11L Engines, Non-Common Rail - Air Compressor Coolant Pipe, Substitution - US14+OBD13 To US14+OBD16

Requested 4/11/2023

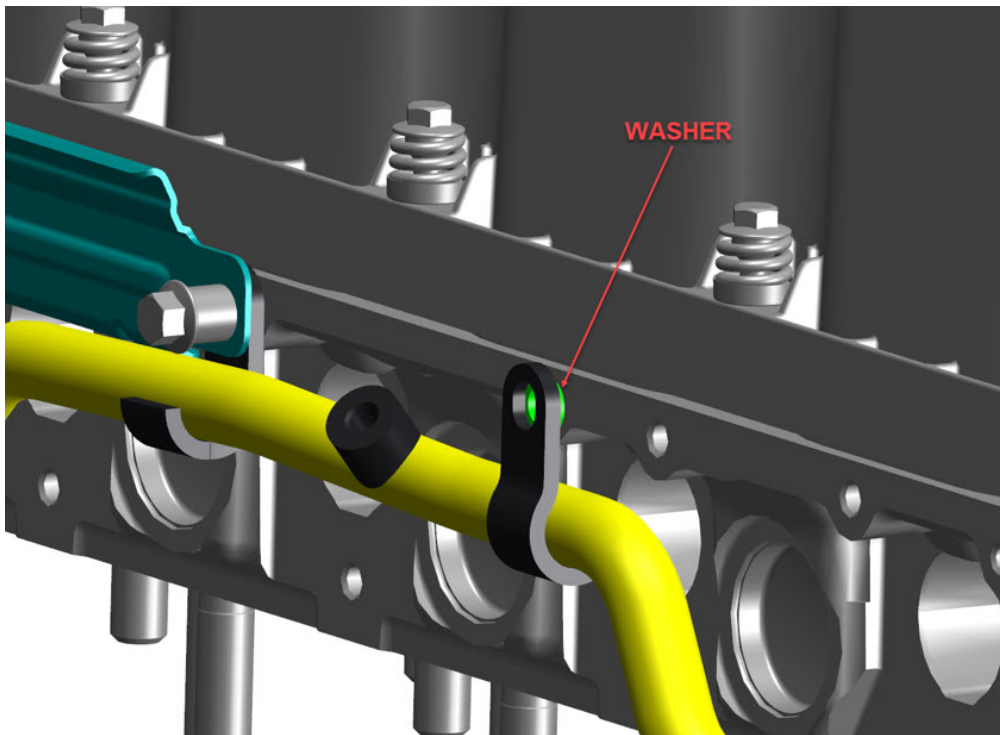
If a vehicle with a non-common rail 11 liter US14 emissions engine (US14+OBD13 to US14+OBD16) requires replacement while part 21921249 is out of stock, follow the information below.

If part 21921249 is out of stock, use part number 23110352, the pipe for current production engines. In addition, a spacer (60113311) should be added to the pipe holddown as shown below.

Part Number	Description
23110352	Air compressor coolant pipe, current production
60113311	Spacer, 2mm thickness
